# 8th Street Mill and Inlay

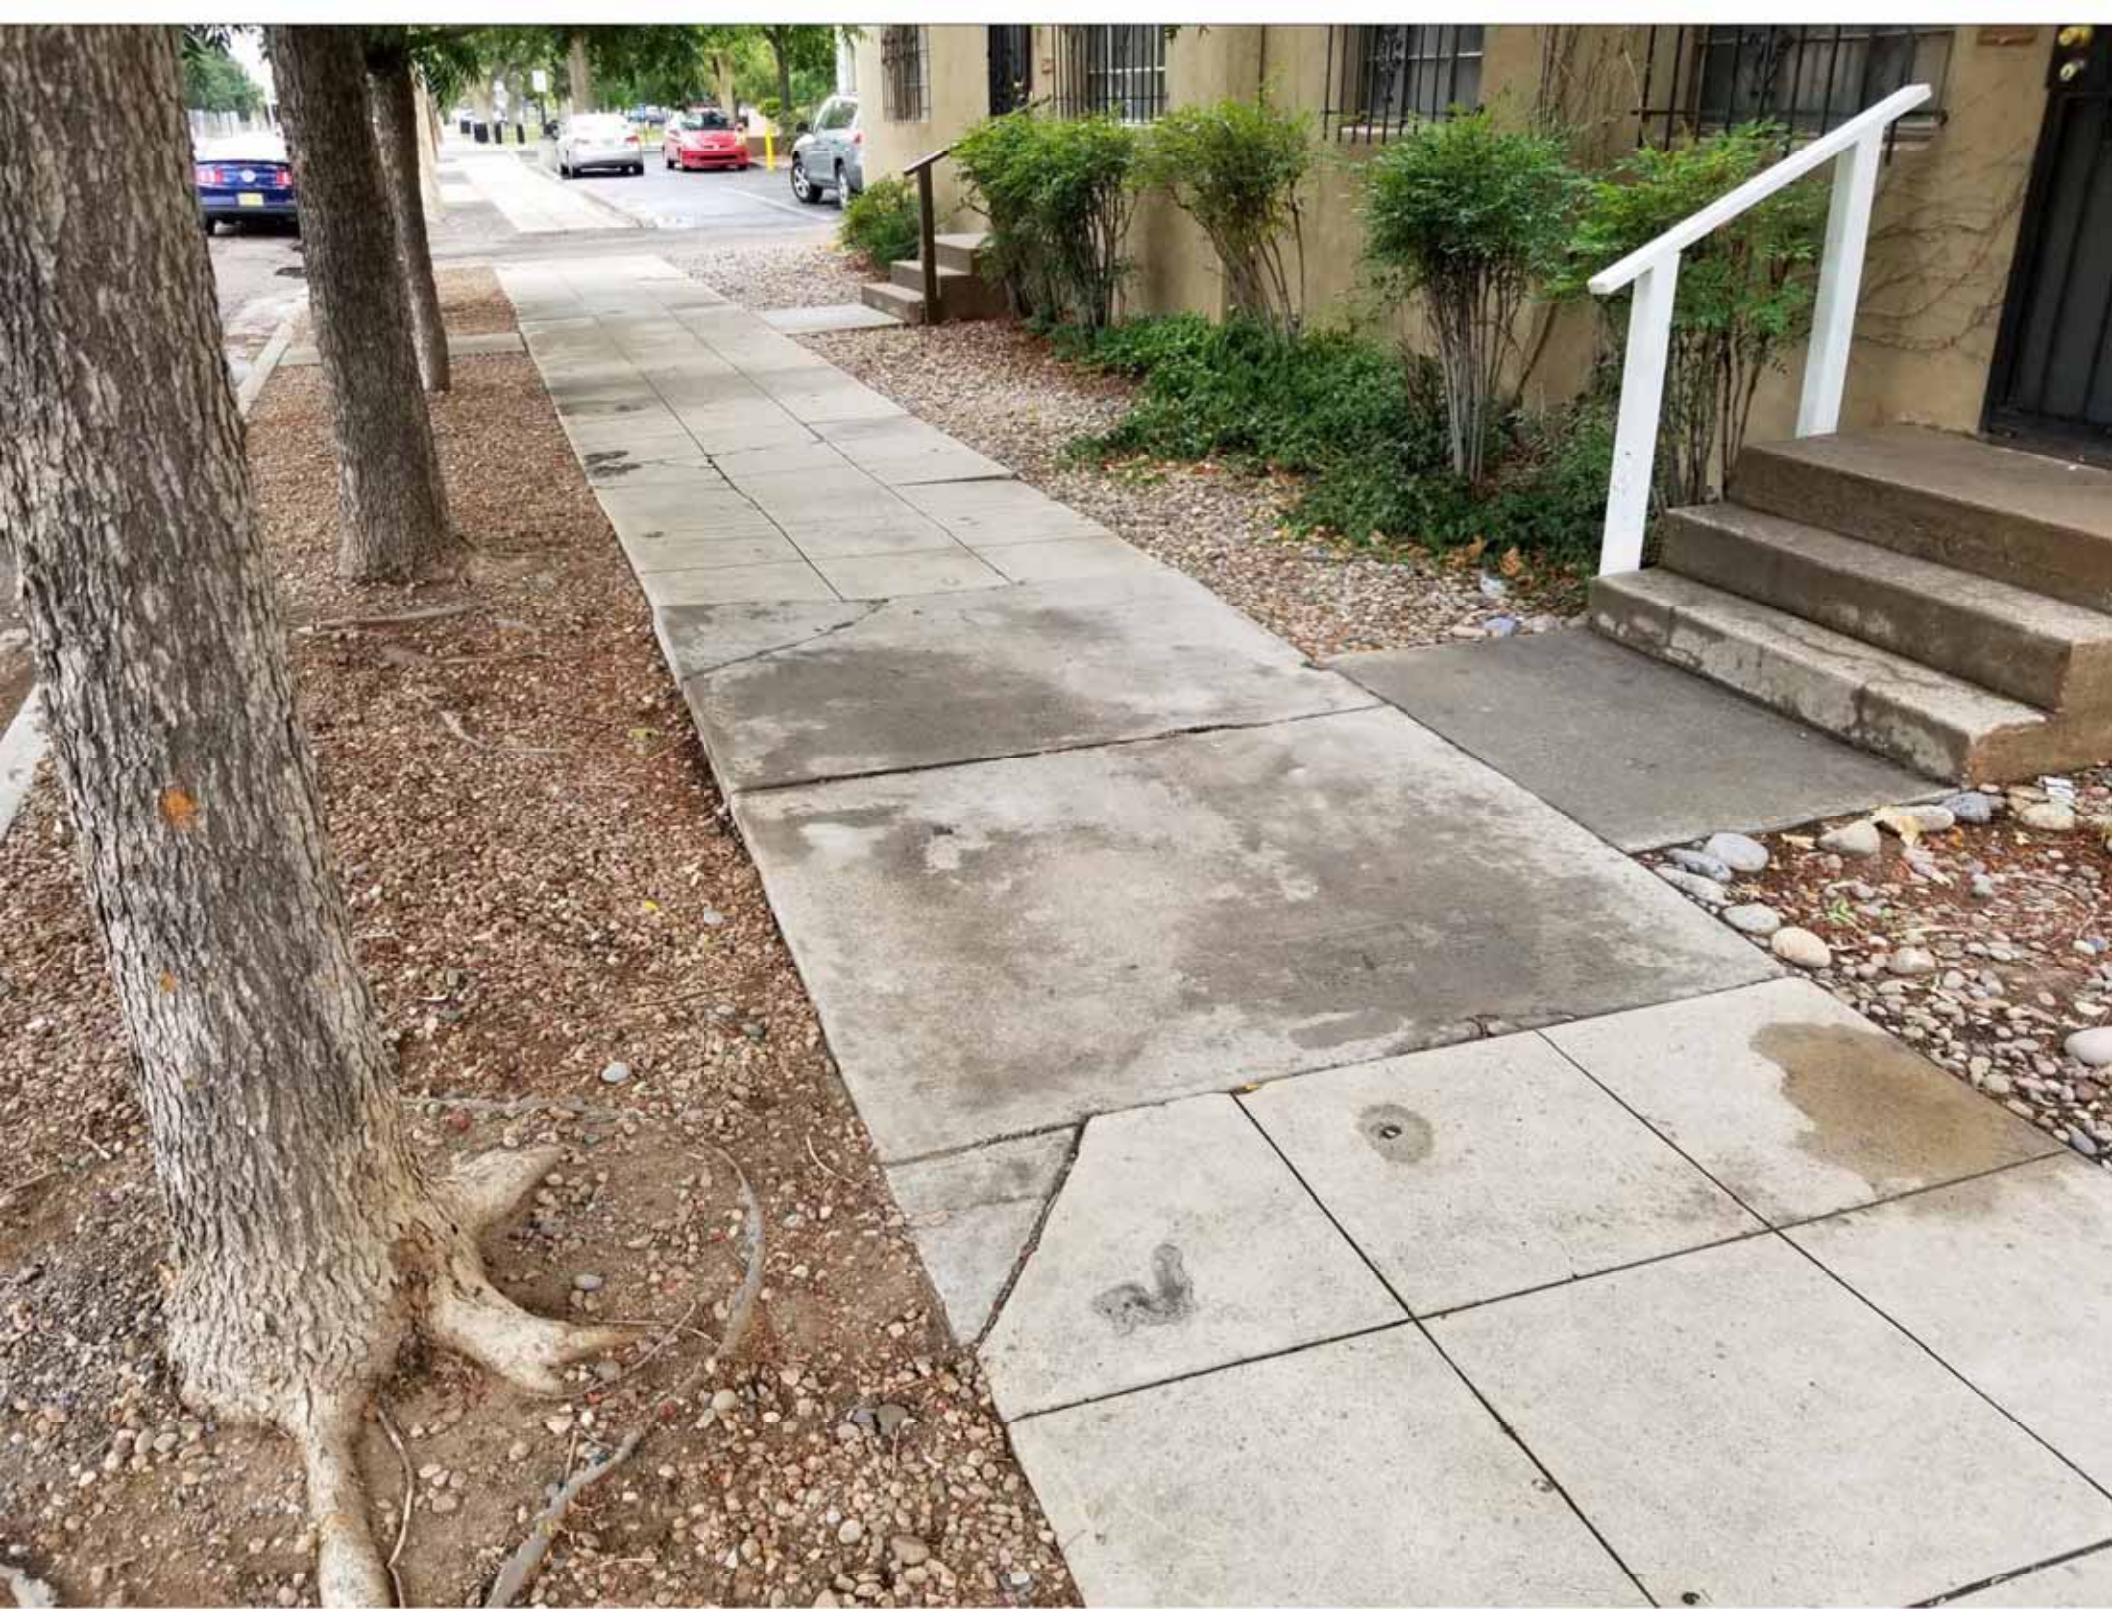
R&R ramp

Remove C&G and  
drive pads, replace  
with gravel

R&R sidewalk  
(damage)

Check C&G for  
flow. Replace?  
(bad condition)

Leave existing  
drive pad

Leave existing  
ramp

Check C&G for  
flow. Replace?  
(bad condition)

Leave existing  
ramp

R&R sidewalk  
(damaged)

R&R sidewalk  
(damaged)

Possible tree root  
mitigation

R&R sidewalk and  
drive pad

Existing pavement  
condition is very  
poor
